# **Official Transcript of Proceedings**

## **NUCLEAR REGULATORY COMMISSION**

**Title:**       Advisory Committee on Reactor Safeguards  
              Radiation Protection and Nuclear Materials  
              Subcommittee Meeting - Open Session

**Date:**               Wednesday, August 19, 2015

# Water Damage

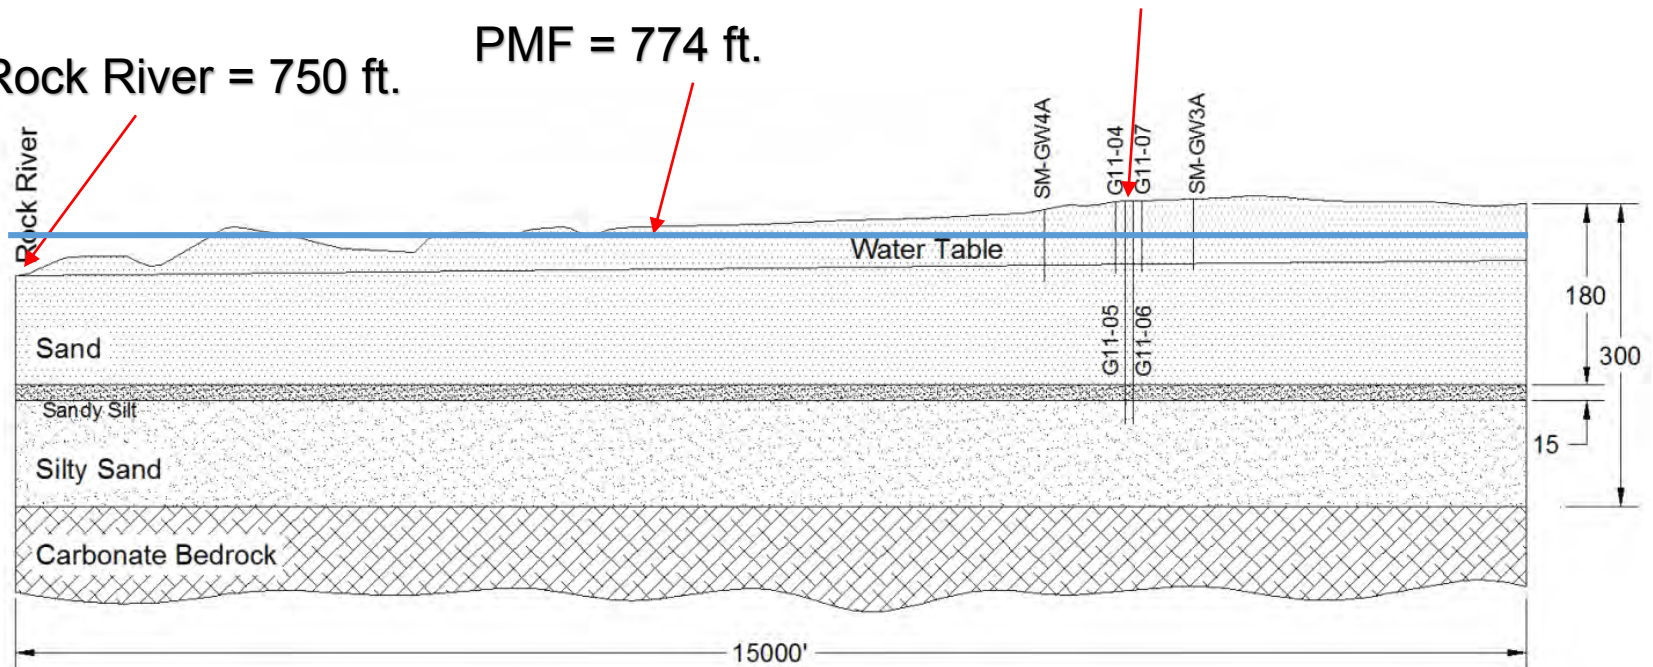
9                   MEMBER SKILLMAN:     John, before you  
10                  proceed, let me ask a question. Let me take you back  
11                  to your flooding -- internal flooding, which is your  
12                  slide nine.

14                  MEMBER SKILLMAN:     Water collection  
15                  system accommodates fire fighting water volume. You  
16                  then describe with great detail the seismic work that  
17                  you did.

7 MEMBER SKILLMAN: So, my question is,  
8 what consideration have you given for loss of water  
9 from the pool on seismic excitation? If none, just  
10 say none.

14 MR. McLEAN: Right. Gordon, let me just  
15 make sure I understand the question. Are you  
16 concerned about the water height due to sloshing on  
17 the side of the pool?

# Fire Hazards Analysis (FHA)

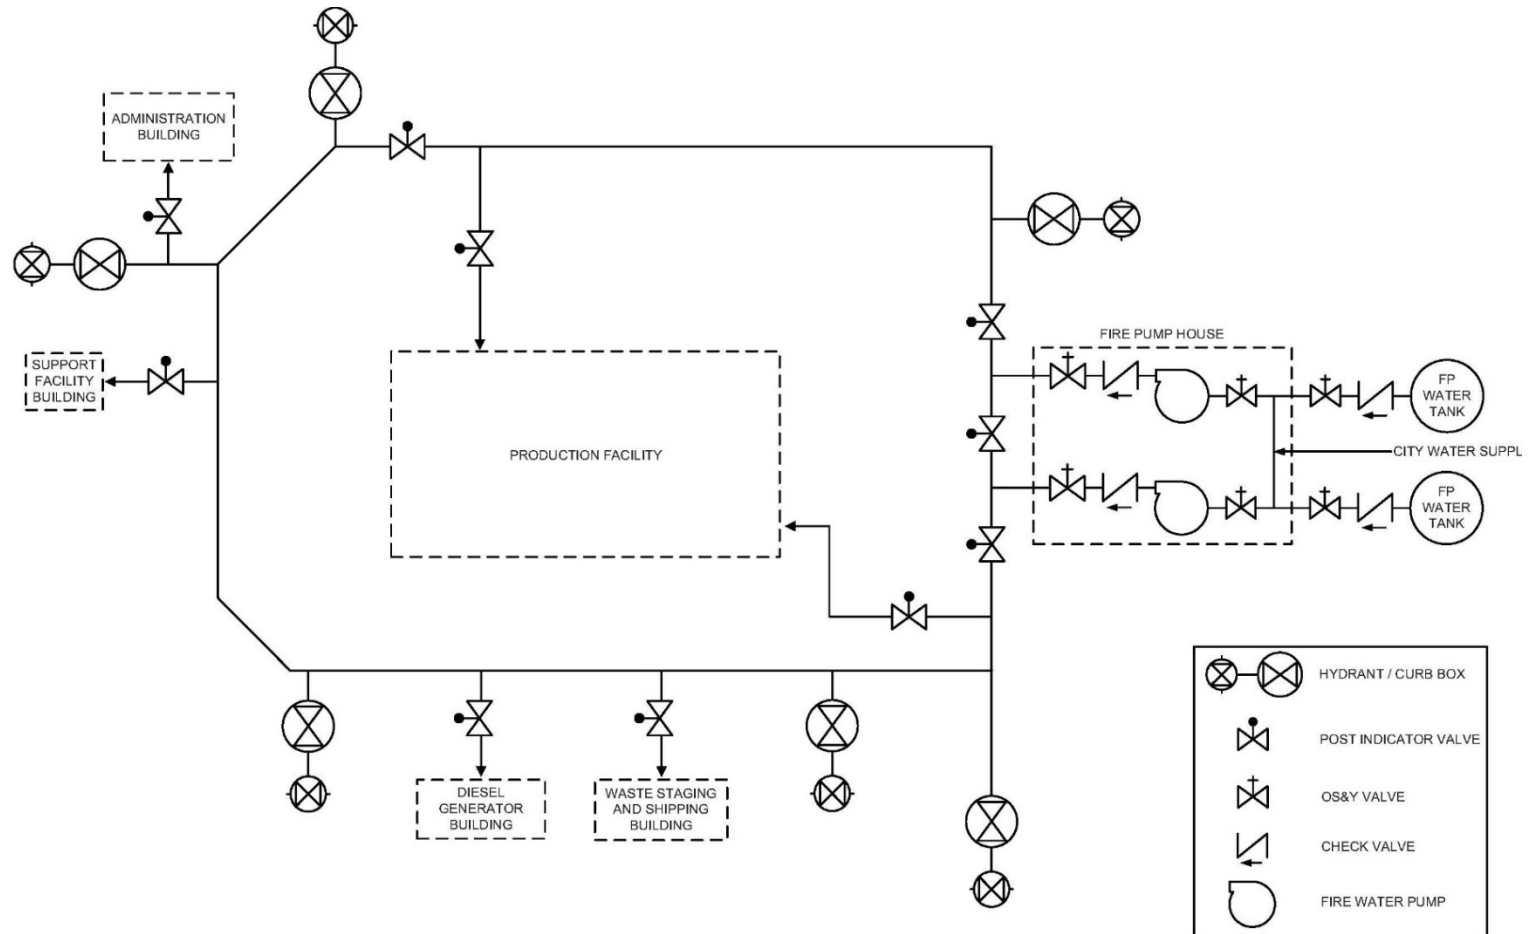
15                   MEMBER STETKAR: It does not seem to  
16      address things like spurious actuations; all it says  
17      is an analysis defining consequences of the fire  
18      breach fire area; this is stated as loss of function,  
19      which means to me a clean failure rather than the  
20      effects of spurious actuations, which are now  
21      required, at least for nuclear power plants, for both  
22      so far deterministic and probabilistic assessments,  
23      and we need to look at heat-related, smoke-related  
24      damage that can cause spurious actuations. And that  
25      further brings into question this notion of having

11 MEMBER STETKAR: On the other hand, it  
12 sort of draws questions, really. This is an area,  
13 this is one of the areas where I'm kind of not quite  
14 sure when it's resolved, because this is now a  
15 building layout, and we're talking about a  
16 construction permit here, which means physical  
17 structures and walls and space allocations and things  
18 like that. This is not the type of thing you  
19 typically go back and--you might not have enough room  
20 to put up enough partitions, and if you do put up  
21 enough partitions, it might get so hot in those little  
22 rooms under normal circumstances that my little  
23 laptop computer doesn't like to be in there. People  
24 have found that problem later in terms of retro  
25 fitting fire barriers to a pre-existing design.

5 MEMBER STETKAR: Well my question is if  
6 you haven't thought about it now, it might get awfully  
7 difficult to think about it later, to fix it later.

3 MR. ALDIERI: I guess I can answer that  
4 kind of briefly. As you mentioned, this originally  
5 was a high level; they separated everything based on  
6 how they separated various components.

8 MR. ALDIERI: I guess we'll note the  
9 question and assess it, and to answer it, I would  
10 probably also use fire protection techniques to  
11 mitigate those as well. For example, as we do in the  
12 nuclear industry, early warning detection or air  
13 sampling systems which detect fires well before, like  
14 days before. So that could be a defense method where  
15 I could put air sampling inside a cabinet, which many  
16 plants are doing now under 805. So--

# Aircraft Hazard Analysis Update

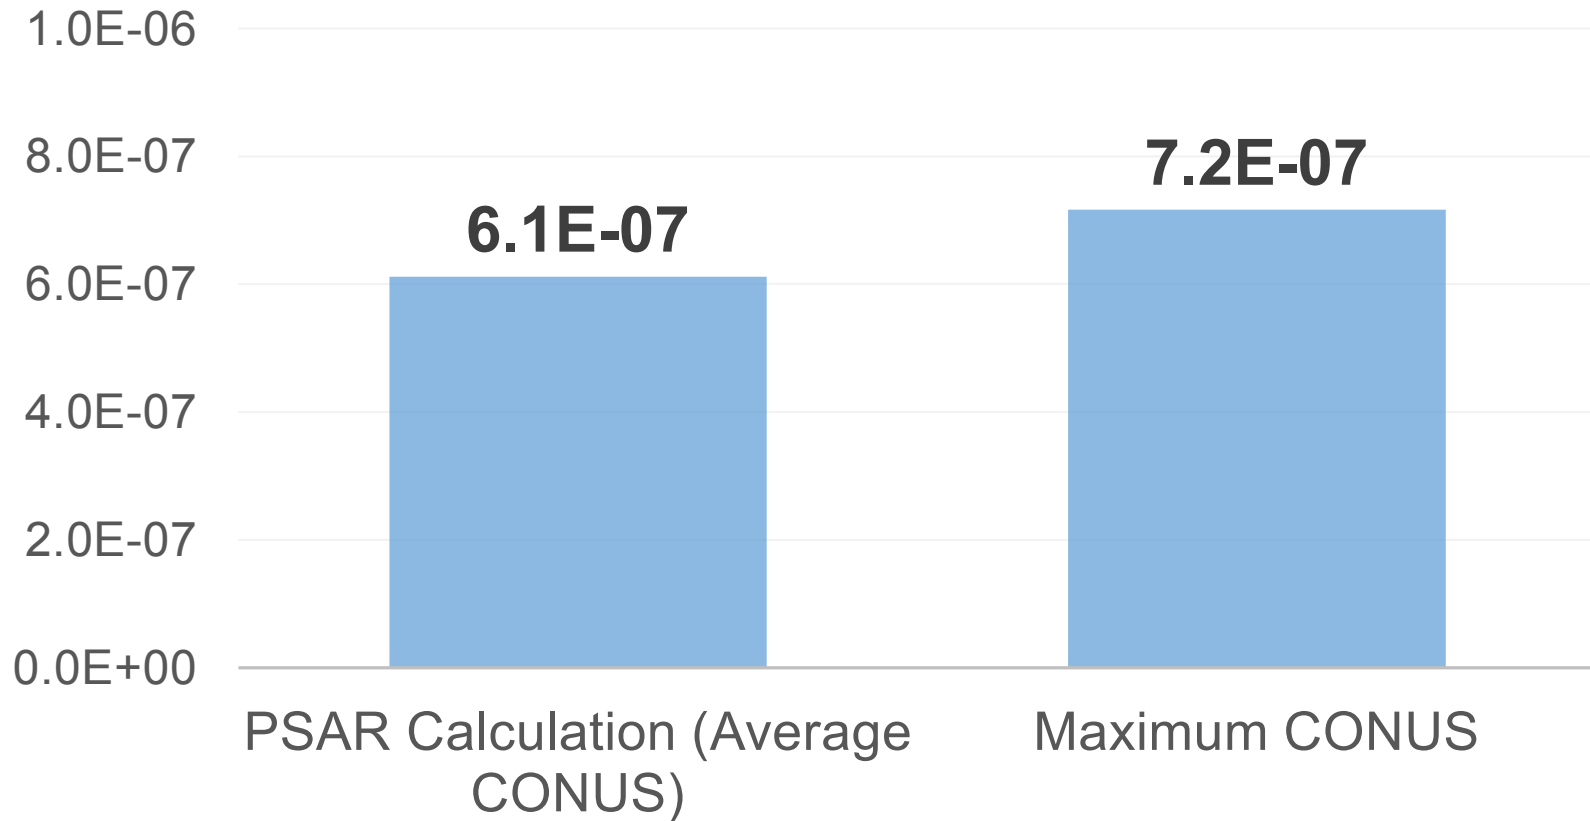
22 MEMBER STETKAR: John, the design for the  
23 aircraft impact is for the small aircraft that you're  
24 using. It's not been screened out from your aircraft  
25 crash analysis, is that correct?

1 MR. McLEAN: That's correct.

14 The next five slides are considering our  
15 aircraft hazard analysis. This is a updated version  
16 of PSAR Figure 2.2-2. We used low and high altitude  
17 charts from the FAA to construct this because the  
18 airways, the low altitude airways converge on the  
19 radio beacon, a navigational aid which is offset  
20 several miles from the airport. So there is one  
21 airway that is almost directly over our site.
